Item: 145kV CT

Customer: APTransco, Andhra Pradesh

List of Standard Drawings/Documents:

REV.NO.	DESCRIPTION	APPV'D	REV. DATE	
GEN. TOL : NA	MATERIAL : NA			
WEIGHT : NA				
DRAWN	M.D.	08.03.2023	SPEC : NA	ALL DIMENSION ARE IN MM. UNLESS OTHERWISE SPECIFIED.
CHK'D	M.C.	08.03.2023	FINISH : NA	
APPV'D	R.P.	08.03.2023		
PIFFNER Instrument Transformers Pvt.Ltd. NASHIK, INDIA			TITLE : GENERAL ARRANGEMENT 145KV CT	DWG NO. APTR-05.31.145J1
			SHEET 1 OF 1	REV. NO. : 00

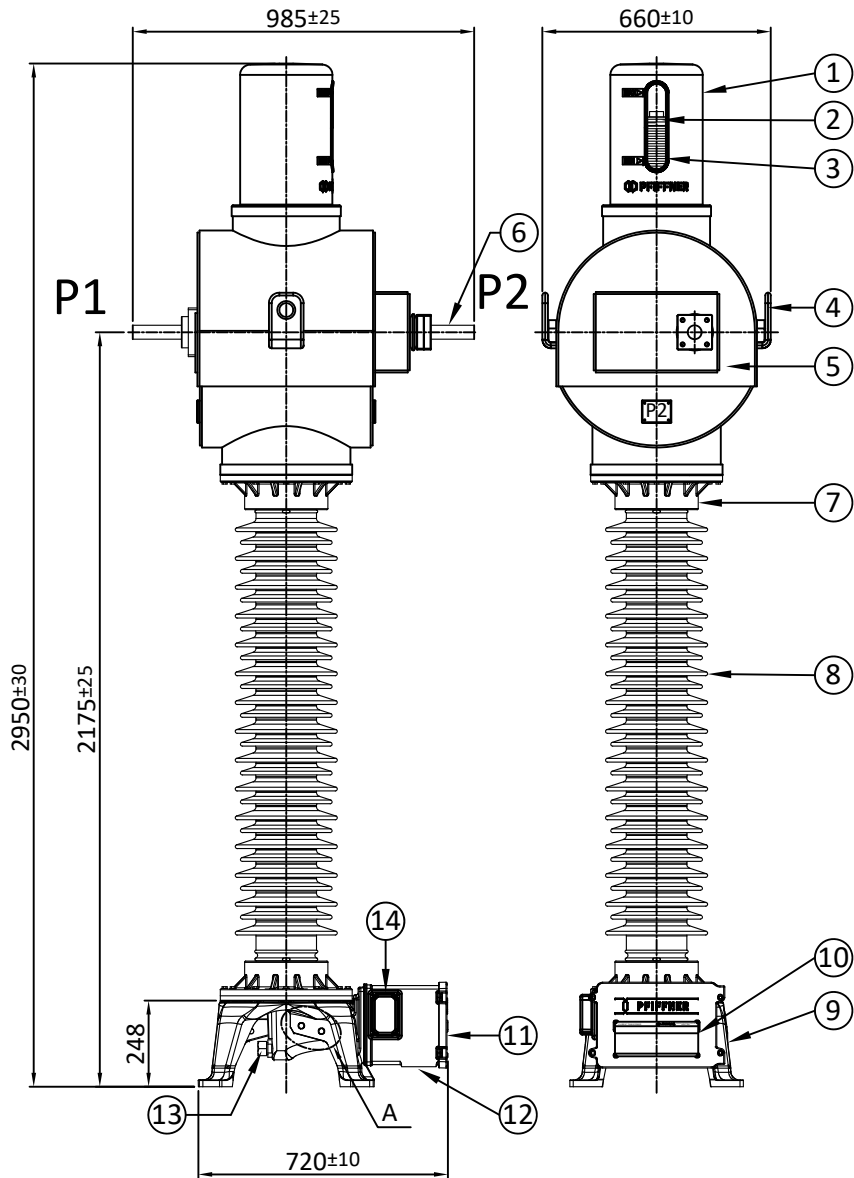
Variation of Tan Delta Value from 10KV $\mu\text{m}/\sqrt{3}$ shall be not exceed 15%.

1. Minimum 300mm plinth shall be maintained for CT/PT/CVT/ Isolators/IVT in the substation during foundation works to ensure safe live to ground clearance as per IE rules.
2. Since the supply of terminal connectors is not in the scope of manufacturers as mentioned in the drawings. The EPC contractors shall be instructed to supply the same in line with CT/PT/CVT/Isolator /IVTs requirement and capatibility.

NOTE:-1. Drawings approval subject to valid type test reports, to be checked during acceptance tests.
2. For EPC contractors only.

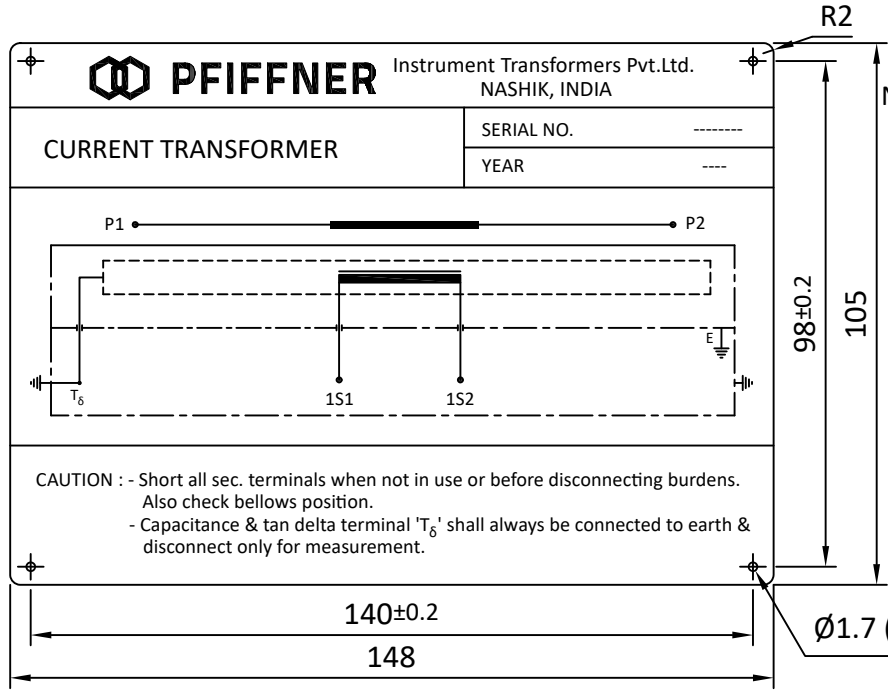
Variation of Tan Delta Value from 10KV um/sqrt 3 shall be not exceed 15%.

NOTE:-1. Drawings approval subject to valid type test reports, to be checked during acceptance tests.
2. For EPC contractors only.

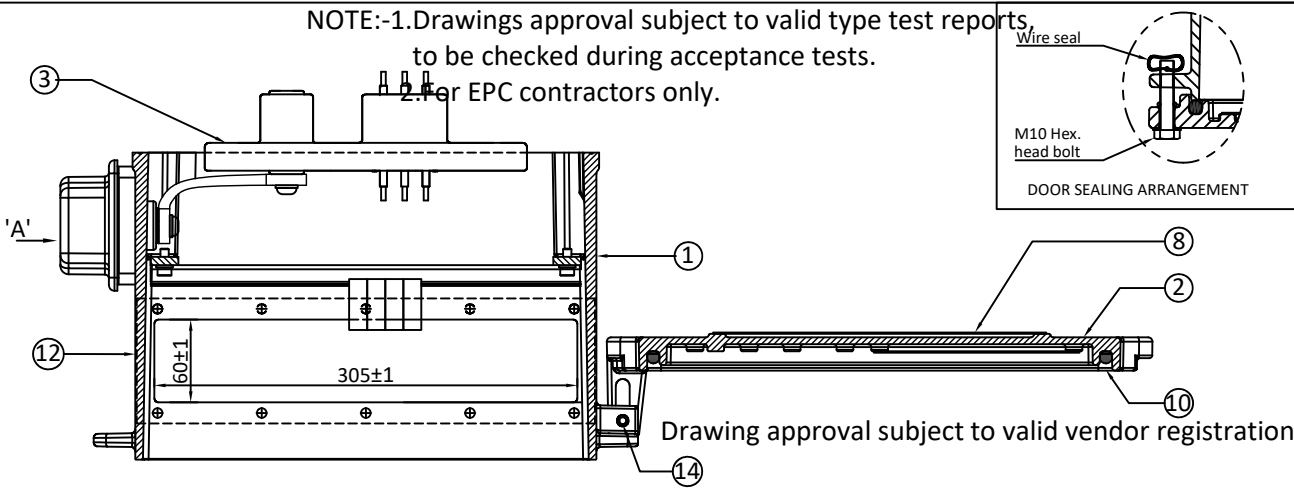
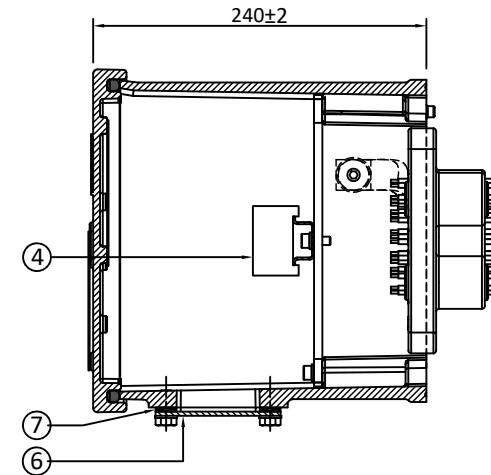
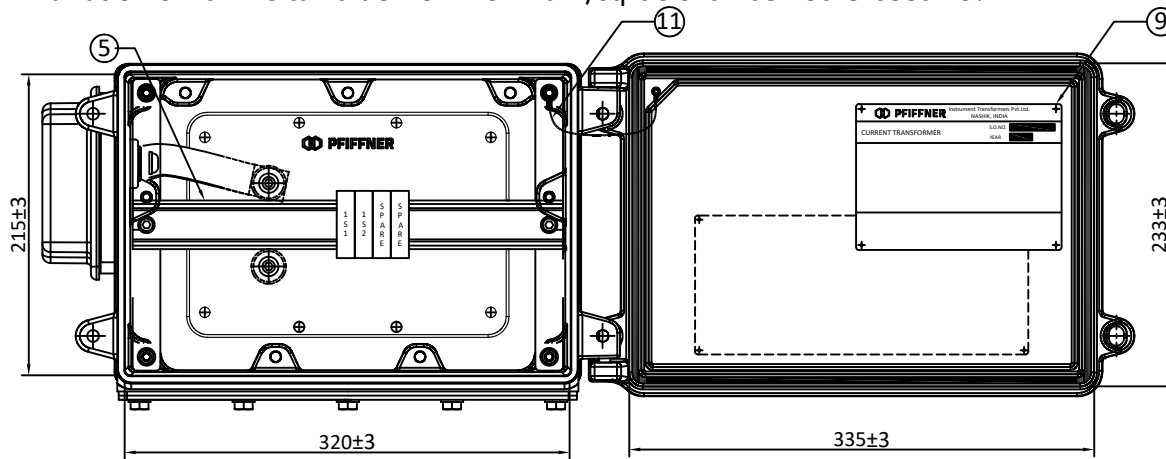
NOTE:-1. Drawings approval subject to valid type test reports, to be checked during acceptance tests.
 2. For EPC contractors only.

Variation of Tan Delta Value from 10KV um/sqrt 3 shall be not exceed 15%.

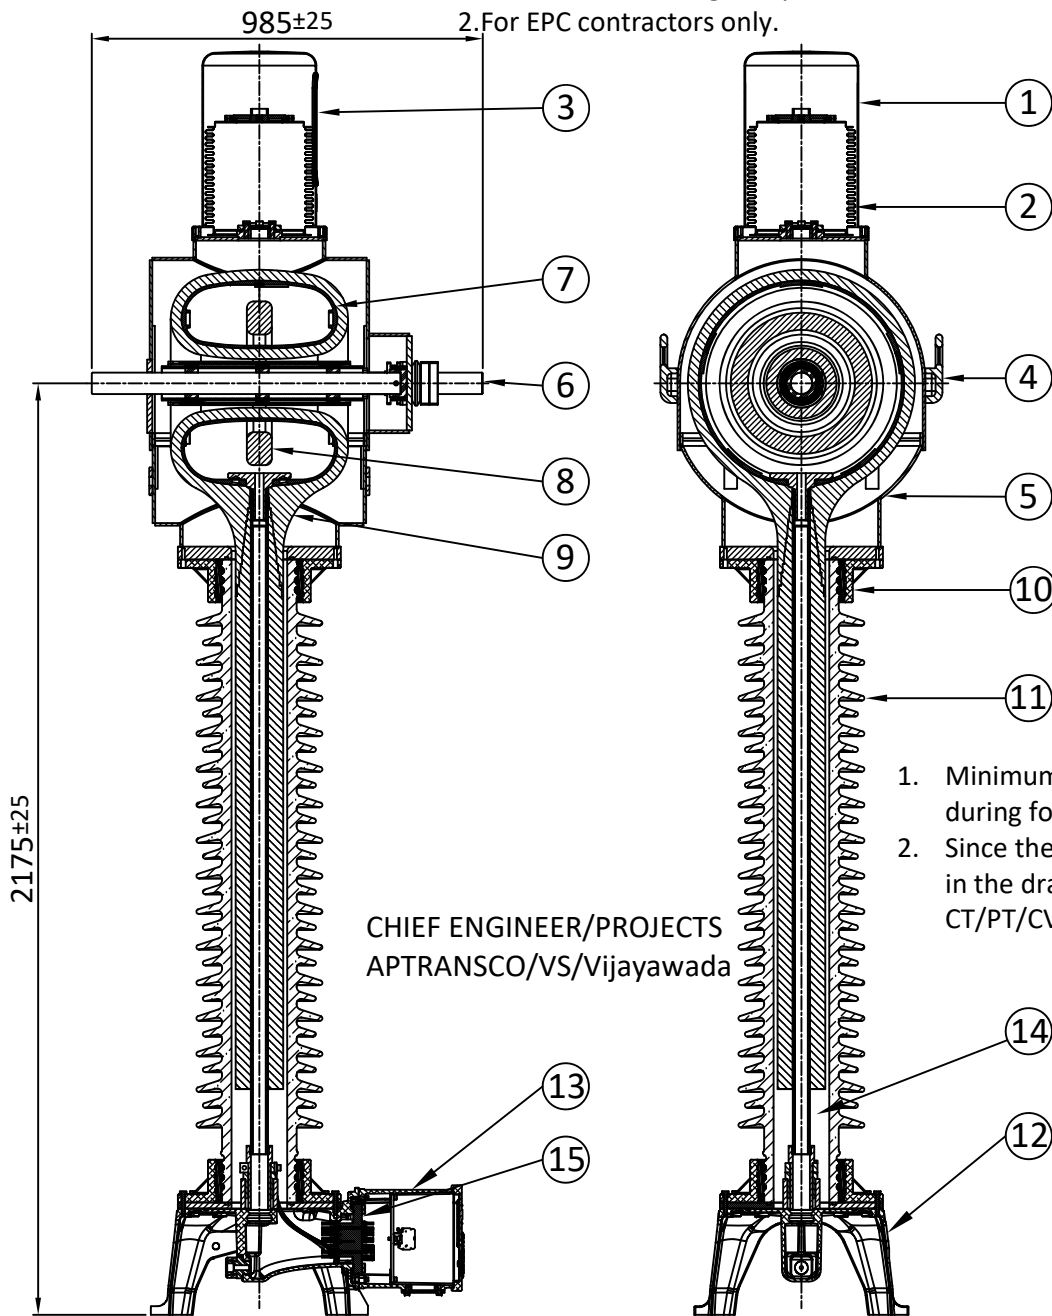
1. Minimum 300mm plinth shall be maintained for CT/PT/CVT/ Isolators/IVT in the substation during foundation works to ensure safe live to ground clearance as per IE rules.
2. Since the supply of terminal connectors is not in the scope of manufacturers as mentioned in the drawings. The EPC contractors shall be instructed to supply the same in line with CT/PT/CVT/Isolator /IVTs requirement and capability.

Variation of Tan Delta Value from 10KV um/sqrt 3 shall be not exceed 15%.
